RIVER DODDER GREENWAY

SUBMISSION BY DODDER ACTION

OPTIONS ASSESSMENT AND PRELIMINARY DESIGN

Dodder Action (DA) proposals for Dodder Greenway Routes and Paths between Templeogue and Ringsend with reference to Feasibility Study Report (FSR) proposals.

Fig. 3 SDCC: Existing path from Kilvere Estate to Springfield Ave. road bridge

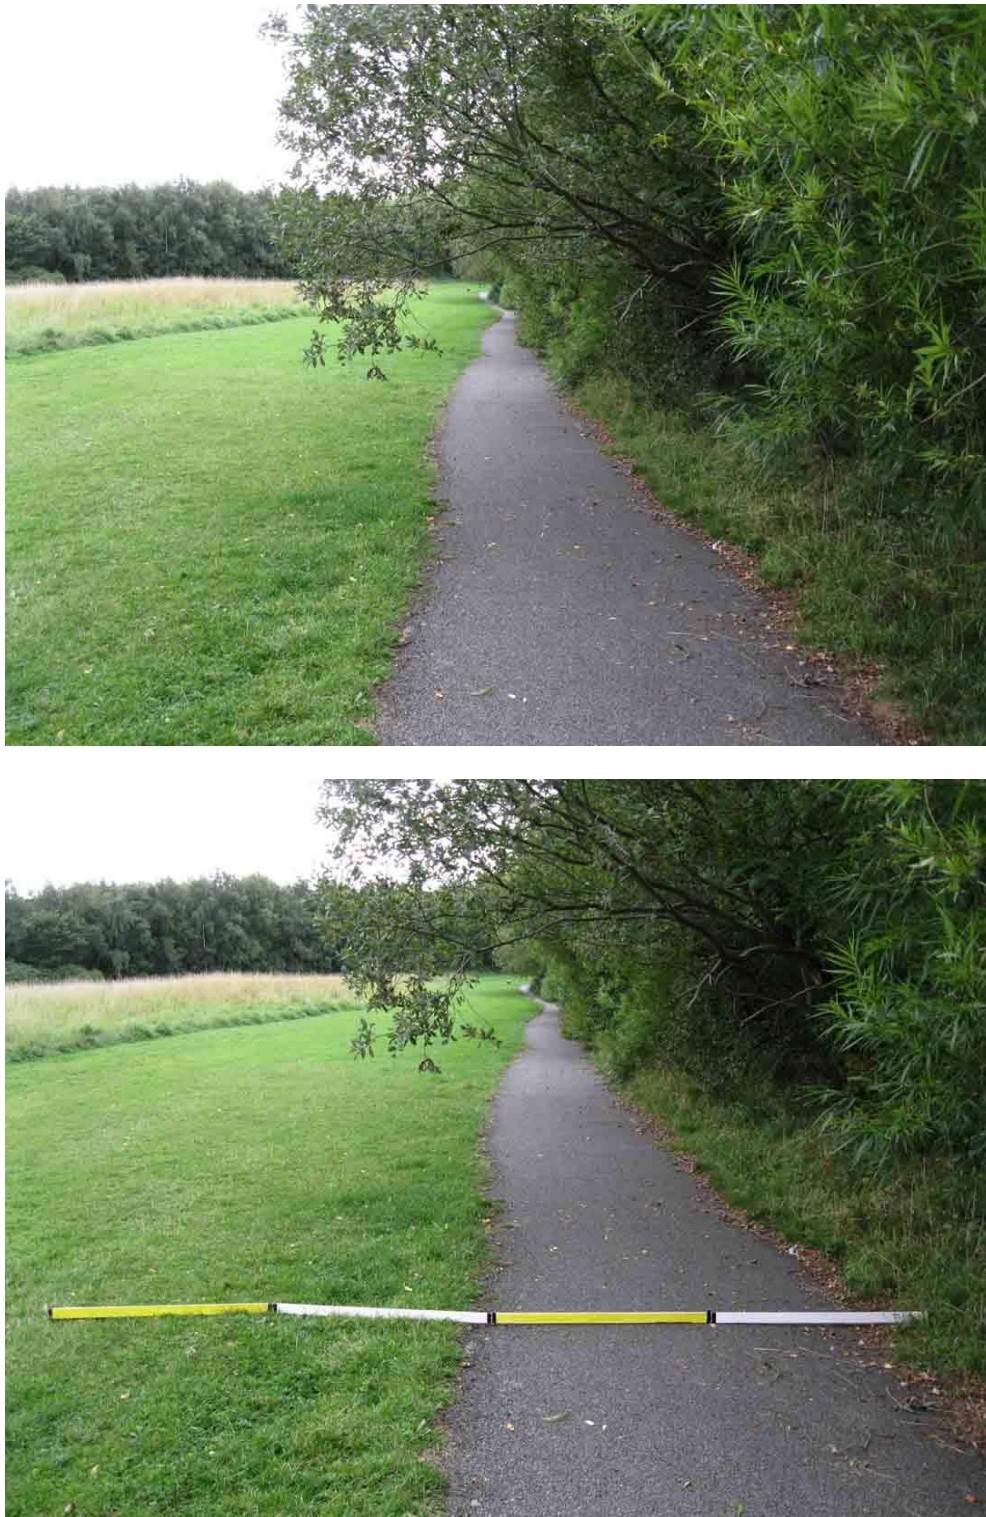
Existing path could be widened to 3.5 m with minor upgrade: This amenity path is used extensively by local residents and by walkers and cyclists following the river as far as possible before the ‘break’ in the riverwalk of approximately 0.7 km to Cherryfield. The path runs between grassland on left, river to right, with extensive trees and hedgerow between river and path.

Fig.7 SDCC: Path from the footbridge (to the Park) to Rathfarnham Rd. Bridge

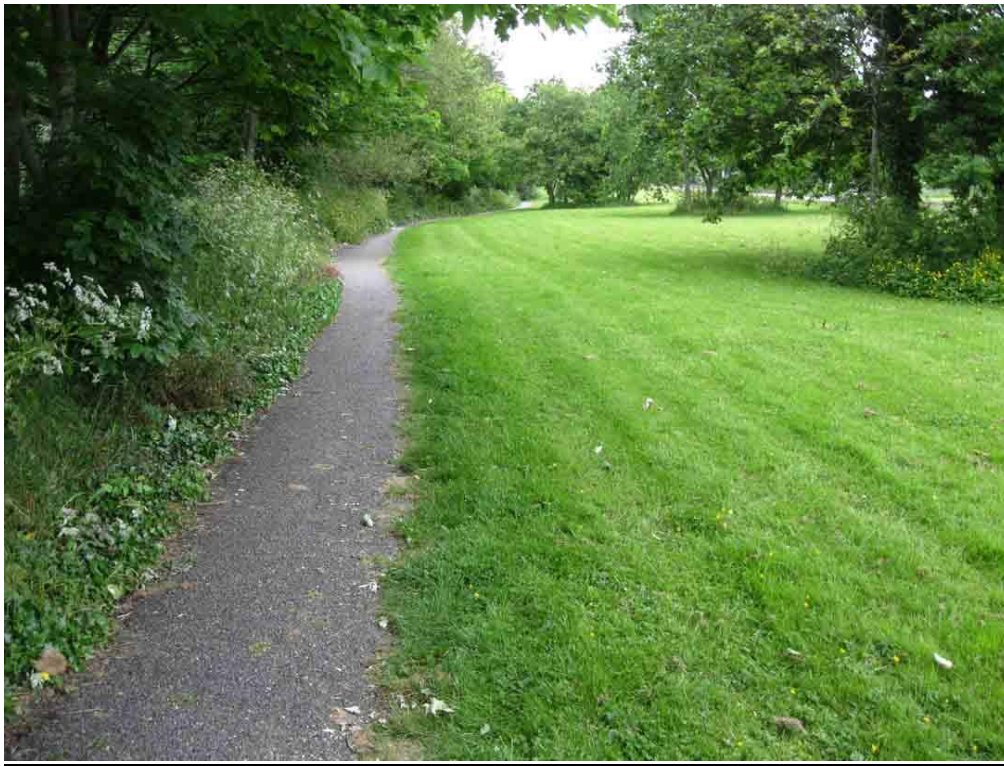
FSR Design: Habitat and visual amenity loss from 4 m track, and margins would increase loss. It is unnecessary as there are dedicated commuter cycle lanes on the road just a short distance away. (See below Fig.11 where this path is visible to the right, similar cycle lane on opposite side of Springfield Avenue). Lighting should be bat-sensitive and minimal as ambient light already from road.

Existing path should be slightly widened to 2/2.5 m with minor works: This walk could be widened to match the path upstream of footbridge. It could then be used by cyclists, and with minor improvements would be feasible for wheelchair use and tour groups. There are mature trees and hedgerow on left, with views to river.

Fig. 15: Steps to Springfield Ave./Dodder View Rd, beside Owendoher, install stair-rails
(Existing road bridge over Owendoher River may be seen to the right)

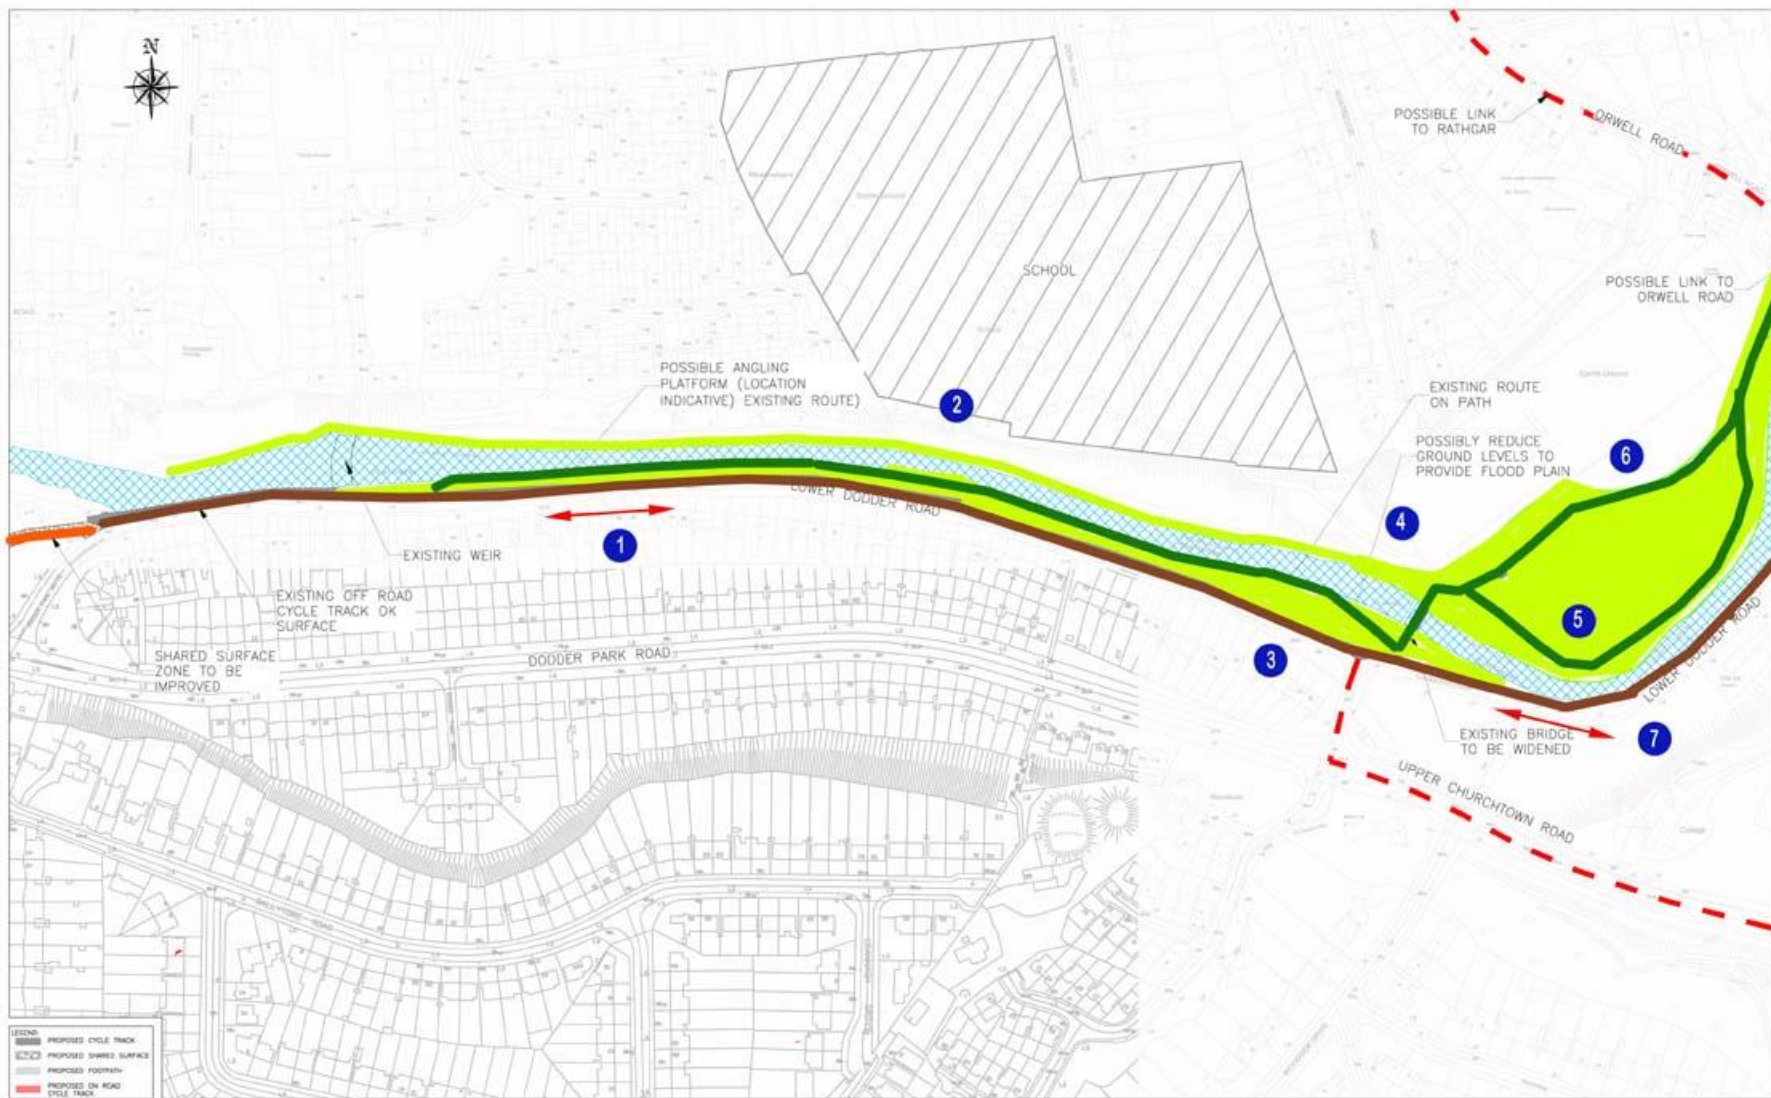
Stair-rails for steps: To facilitate connectivity for leisure cyclists and tourists, stair-rails (U-shaped metal channels for bicycle wheels at the side of steps) should be installed on the steps just beside the road bridge over the Owendoher.

Fig. 17 DCC: Path (inner) through Orwell Park from footbridge to gate

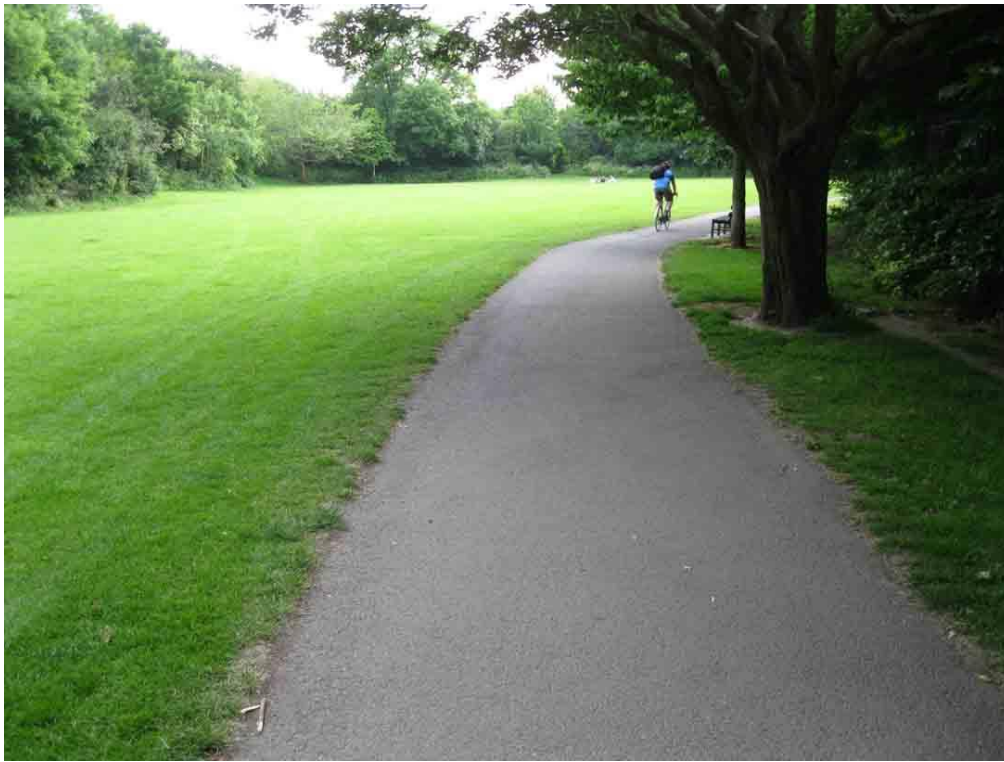
FSR Design: These paths are more than adequate in width for existing and potential use, even adjacent to a narrow two lane roadway. The measuring stick appears to indicate that the design path proposal of 4 m width for combined pedestrian and 2-way cycle use is excessive and unnecessary.

Existing path could be widened to 3 m with minor works: this path is used by walkers and cyclists, beside a high amenity expanse of parkland. It could be widened to 3 m.

Fig. 20 DCC: Path from Orwell Bridge to Dartry Park at Orwell Weir

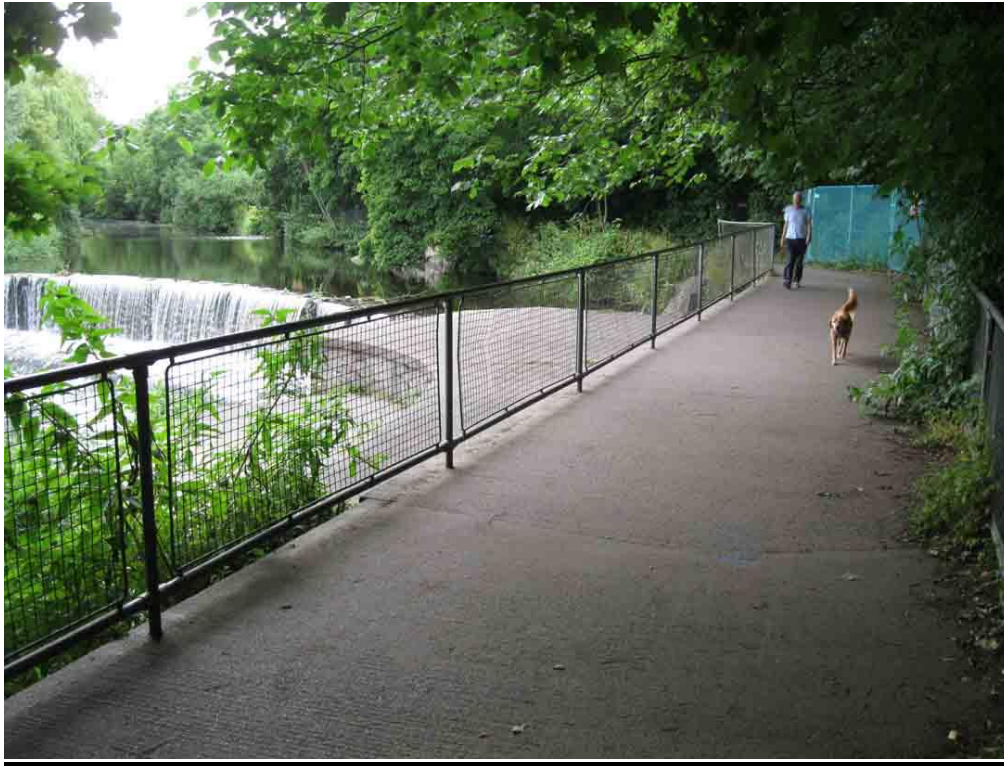
FSR Design: The 4 m stick indicates that the design path is entirely unfeasible here (let alone 1-2 m margins both sides). Any widening would result in a major loss of landscape character, habitat and visual and social amenity within the Conservation Area of the Dodder.

Existing path should be retained as is with minor upgrade: As above, this is a high amenity traditional path, in continuous use for over a hundred years. Beside the picturesque weir, it adapts to the heritage millrace structures, which should be restored. It is in constant use and a favourite place for the local community to stop and talk.

Fig. 21 DCC: Path from Orwell Weir to Dartry Park

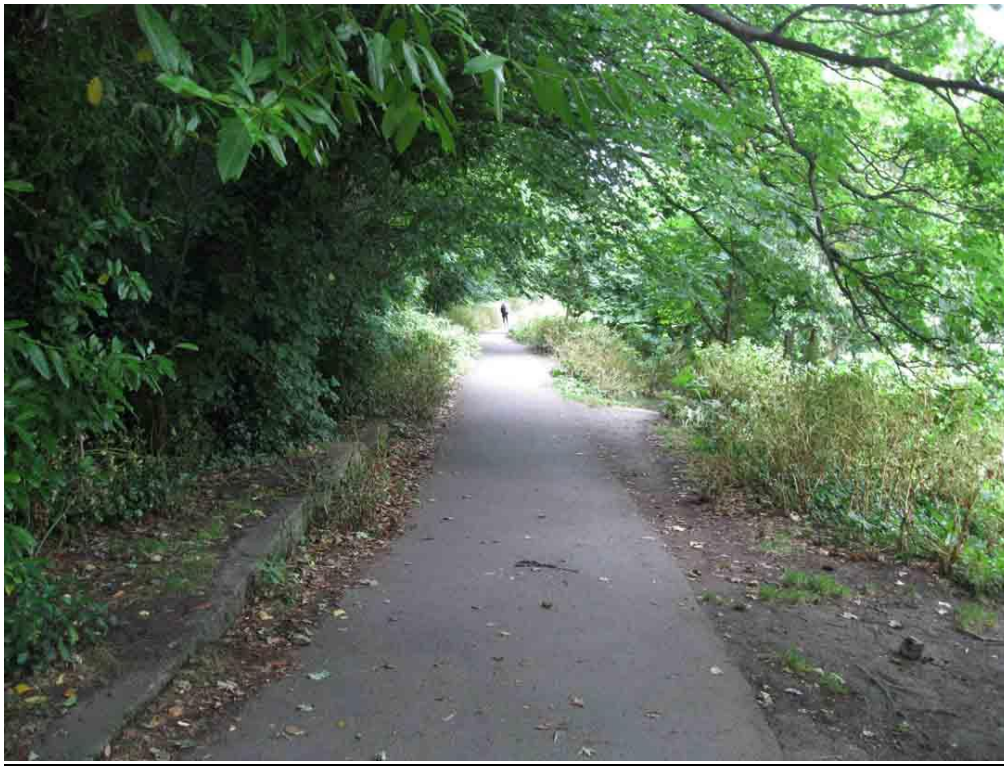
FSR Design: The 4 m stick indicates that the design path is unfeasible here (let alone 1-2 m margins both sides). Any widening would result in a major loss of landscape character, heritage and visual and social amenity within the Conservation Area of the Dodder

Existing path should be retained as is with minor upgrade: This is a high amenity traditional path, intensively used. A millrace ran to the left of this path, and its path should be determined to see how it could be highlighted with minimal disturbance of existing trees and shrubs.

Fig. 23 DCC: Main Inner Path through Dartry Park

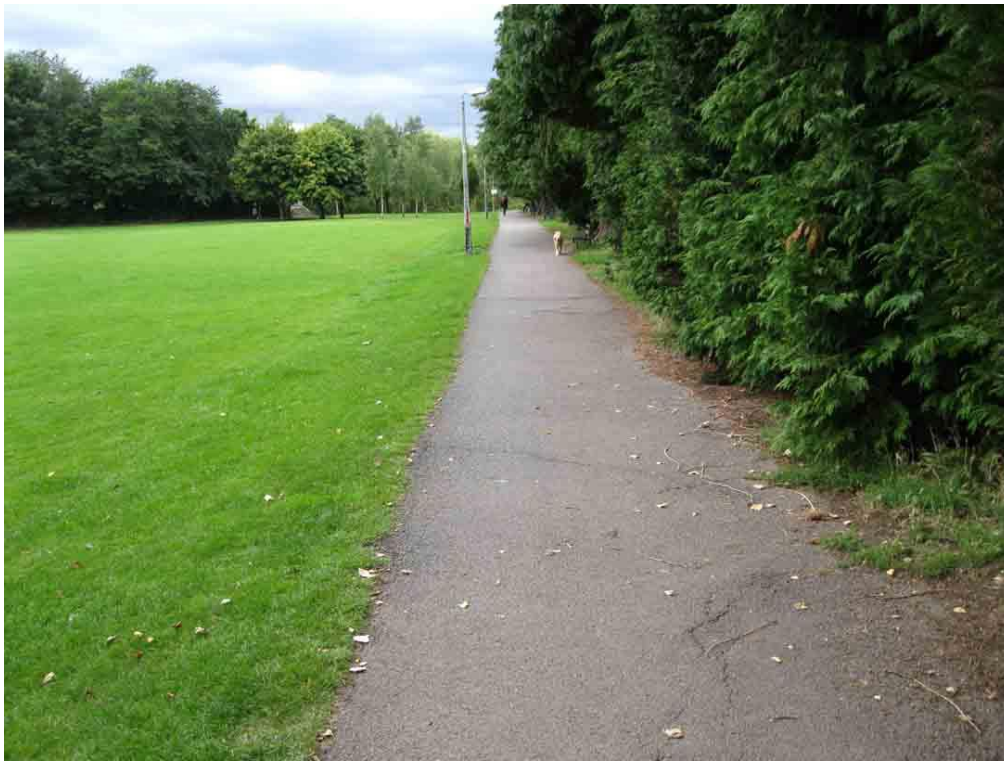
FSR Design: Habitat, landscape character and visual amenity loss from 4 m track, and 1-2 m margin would increase loss, in particular of the trees shown. Lighting should be bat-sensitive and minimal.

Existing path could be widened to 3.2 m with minor upgrade: This is a high amenity path, in constant use. It would be a ‘combined’ route for all users, serving the ‘through traffic’ route across the amended footbridge to Dodder Vale, and the predominantly pedestrian route to Orwell Park. To the left is a frequently used playing field, and any encroachment should be limited as much as possible.

Fig. 39 DCC: River walk between Classon's Bridge and the Nine-Arch Bridge

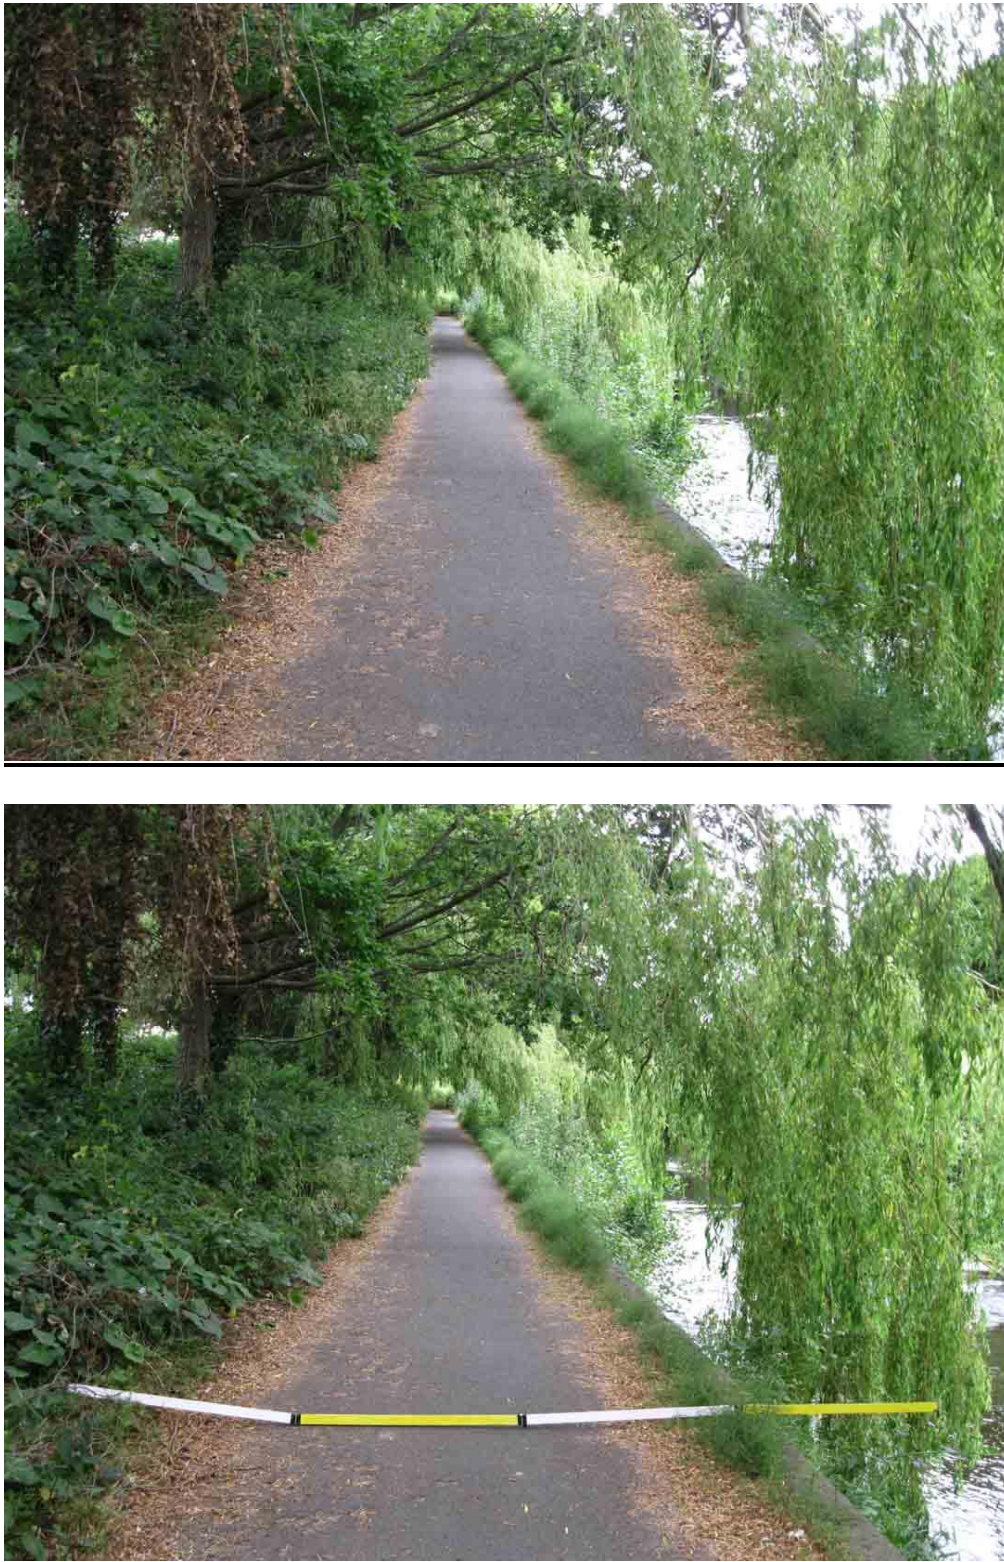
Existing path should be retained as is: It is used intensively. It is of high visual amenity with stone river walls both sides, a hedgerow to left and framed by weeping willows. It is wide enough for pedestrians and other uses, and for leisure cyclists to pass.

Fig. 41 DCC: River walk between Shanagarry Apartments and the river.

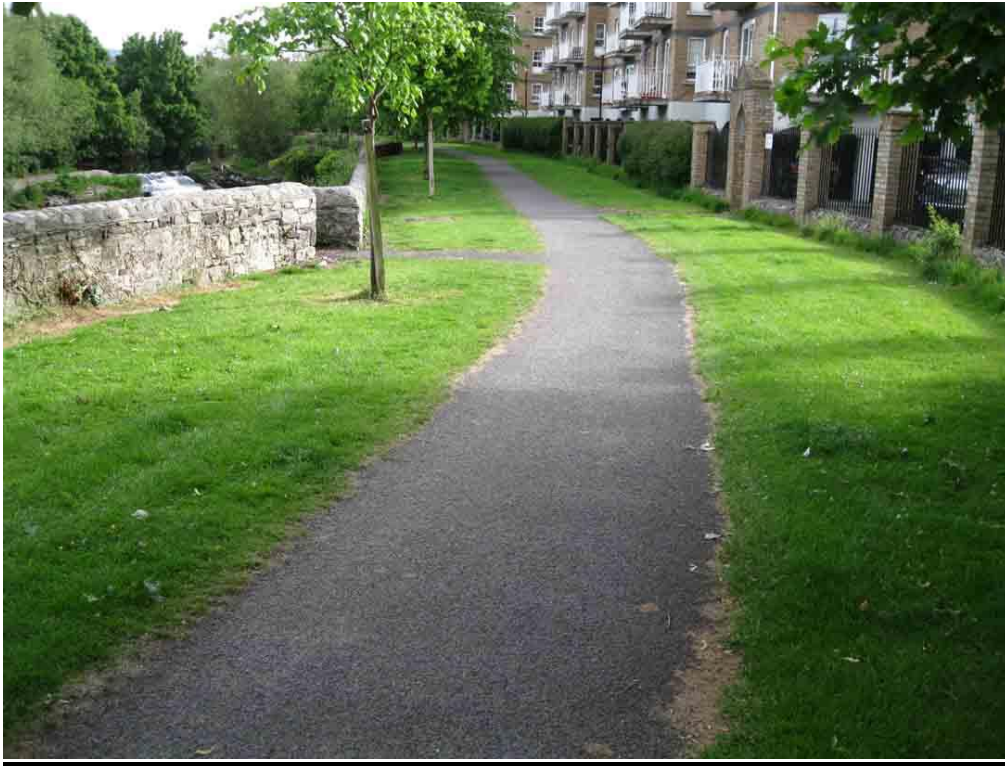
FSR Design: The 4 m stick indicates that the design path would result in loss of trees and habitat and unique landscape character and visual amenity. and there should be no ‘margins’ as they would increase loss, Lighting is unnecessary as there is sufficient ambient light, and is unsuitable for habitat.

Existing path should be retained as is: It is used intensively. It is of high visual amenity with views of the river, the protected Packhorse Bridge and the weir (visible to left). It is wide enough for pedestrians and other uses, and for leisure cyclists to pass.
